62-64 EASTERN PROMENADE.

CITY OF PORTLAND, MAINE  
MEMORANDUM

TO: Kevin Carroll, Code Enforcement Officer  
FROM: Warren J. Turner, Zoning Specialist *W.J. Turner*  
SUBJECT: 64 Eastern Promenade - Re: A Possible Basement Apartment Unit and Combining Two Others  
DATE: 12/10/82

2<sup>nd</sup> Floor

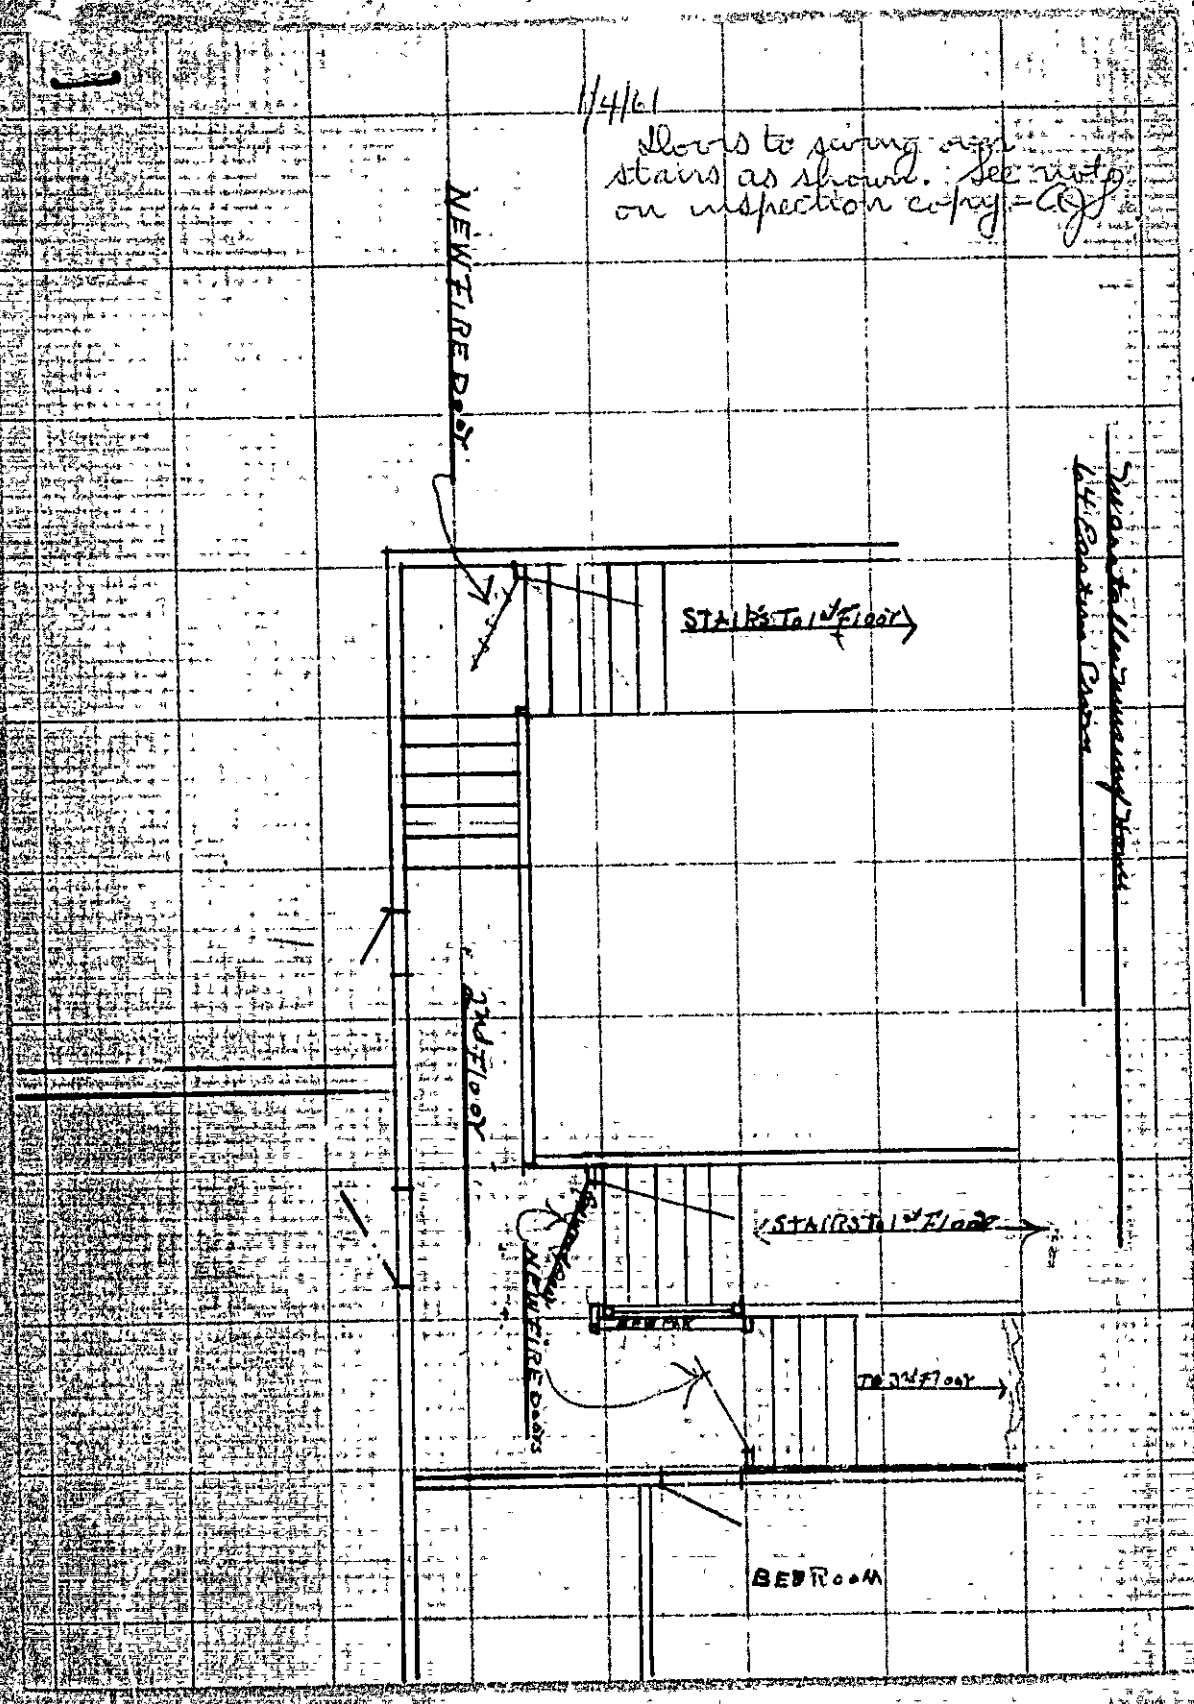
plans to swing open stairs as shown. See notes on inspection copy - C.J.

Swing to Landing and stairs  
to East side

Remove  
Fire door

2. It is important that doors on openings in stairway enclosures swing away from the stairs as indicated on plan filed with application for permit and not directly over them in such a way as to create a bad accident hazard.
